Re: Addendum to Pedestrian Level Wind Study  
1047 Richmond Road, Ottawa, ON  
GW File No.: 21-416-WTPLW-R2–Addendum

PROJECT 1047 RICHMOND ROAD, OTTAWA  
PEDESTRIAN LEVEL WIND STUDY

FIGURE 3B: SUMMER  
EXPECTED FUTURE PEDESTRIAN  
COMFORT BASED ON PREVIOUS SITE  
CONFIGURATION WIND TUNNEL TEST

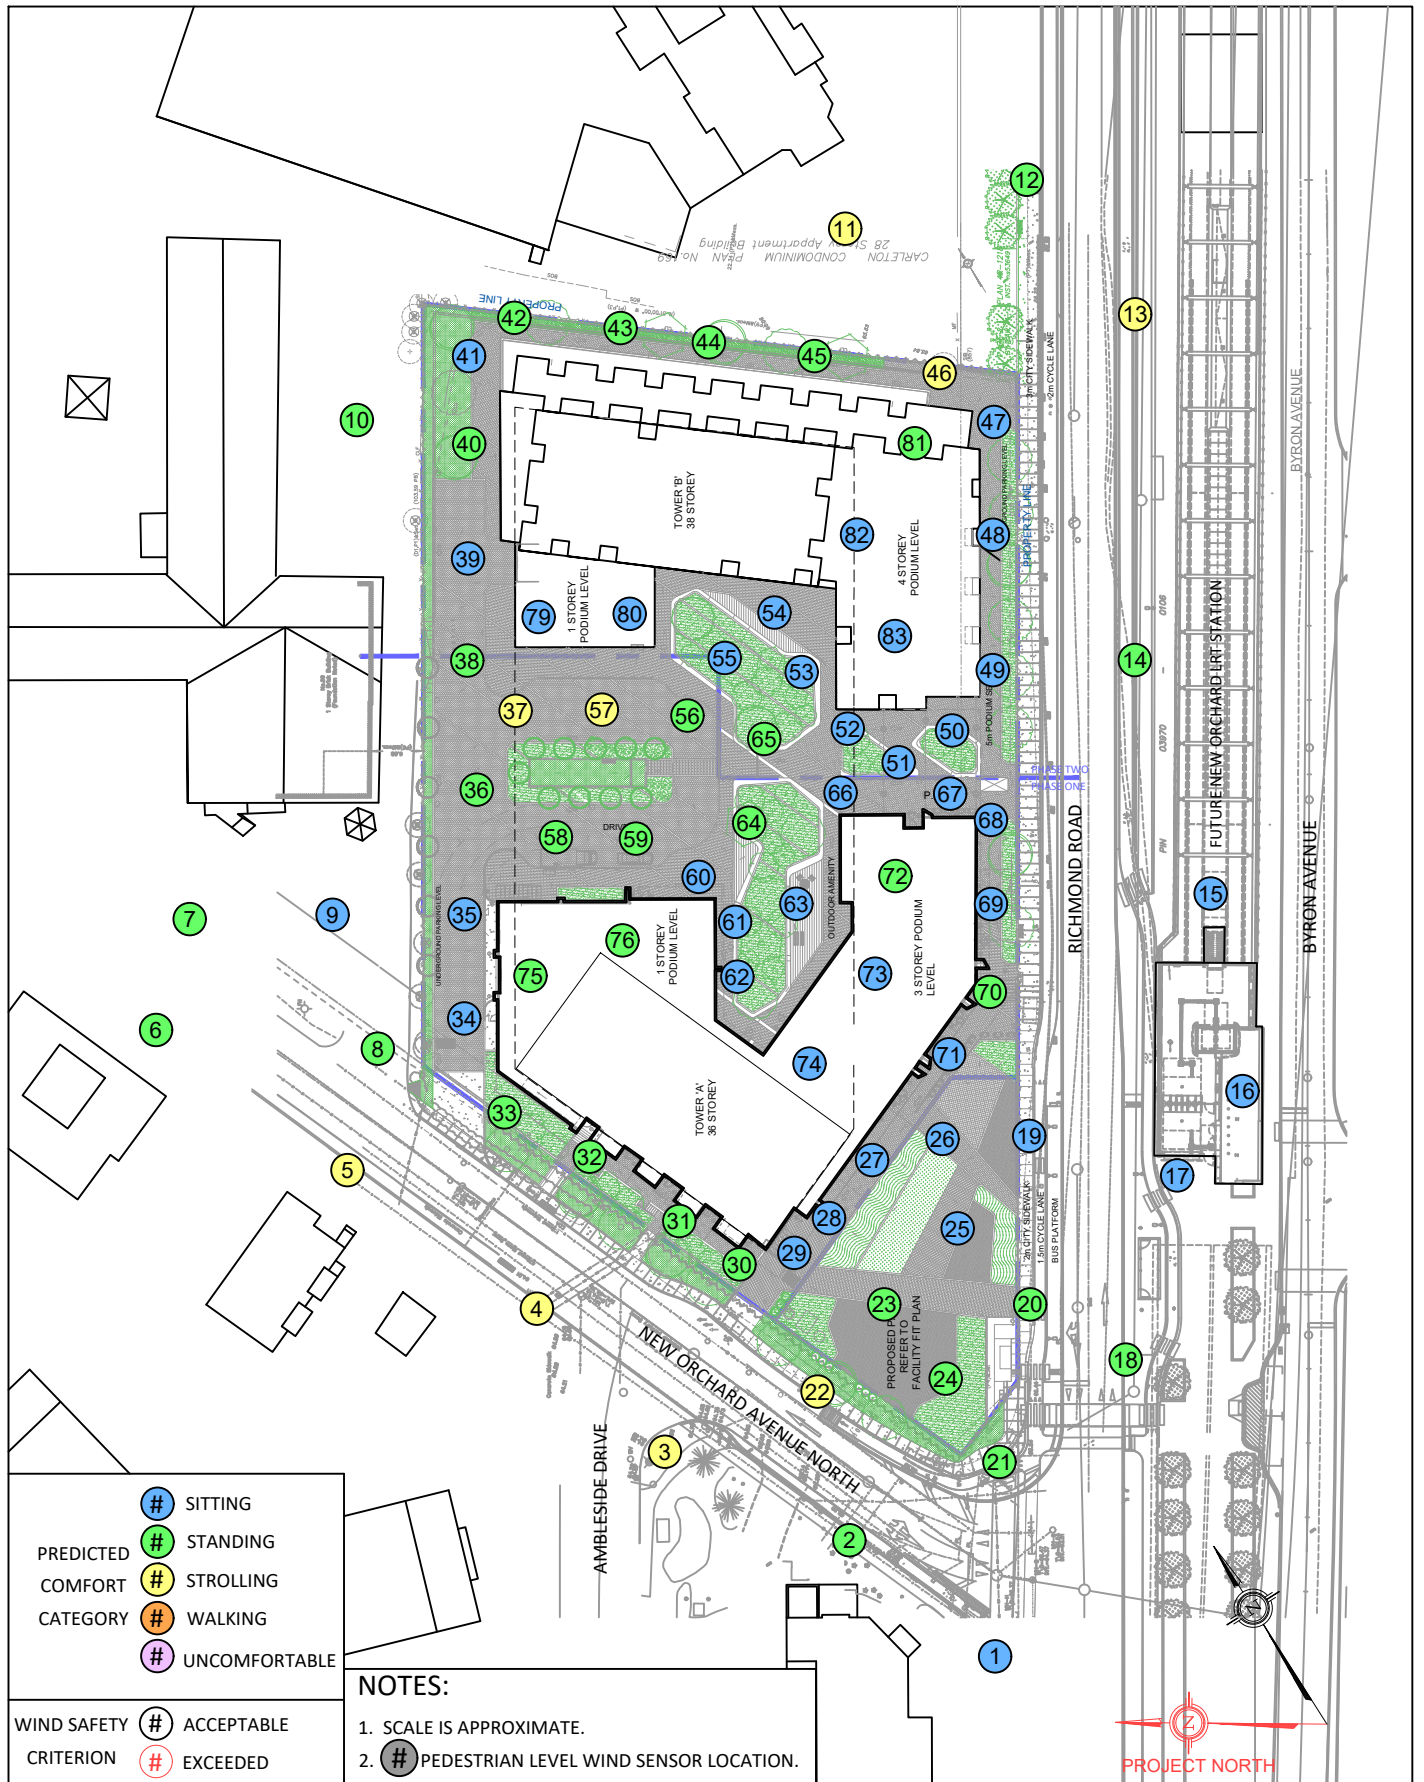
1. A decrease in tower height is generally associated with a decrease in windspeeds at grade and lower terraces, however, considering the relatively minor reduction, wind comfort categories are generally expected to remain similar to those originally recorded. With the shift of the tower to the southwest and where the tower no longer steps back from the podium, windspeeds are expected to somewhat increase immediately adjacent to the study building façade (Sensors 29-32) with the unbuffered downwash of prominent westerly winds towards grade and acceleration around the building corner. This effect is expected to be significantly reduced along the well sheltered south elevation (Sensors 27 & 28). Overall, the walkway along the noted podium façade is still expected to be suitable for walking or better on a seasonal basis, which is acceptable.

2. The reduction in podia height and greater separation between the east and west podia along the north side is expected to significantly reduce the capture and channeling of salient westerly winds between the buildings. Wind comfort is expected to improve over the central drop-off, outdoor amenity, and P.O.P.S., with many previously uncomfortable conditions eliminated during the colder seasons.

3. Regarding the landscaping plan, the density and species of plantings proposed between the Tower A and B podia, and along the north elevation of the driveway, are expected to effectively buffer the prominent northerly winds channelled between the buildings, particularly during the warmer seasons, and generally mitigate the previously uncomfortable conditions observed during the colder seasons. Additionally, the noted amenity areas are well sheltered and generally expected to be comfortable for sitting throughout the warmer months.

The coniferous shrubs and deciduous trees proposed to the west along New Orchard Avenue North are expected to buffer northwesterly wind flows traveling along the roadway and into the proposed park, which is generally expected to alleviate uncomfortable conditions along the sidewalk. Within the park, standing or better conditions are generally expected during the warmer months, with additional buffering to be expected from any future amenity or landscaped features within the park plan.
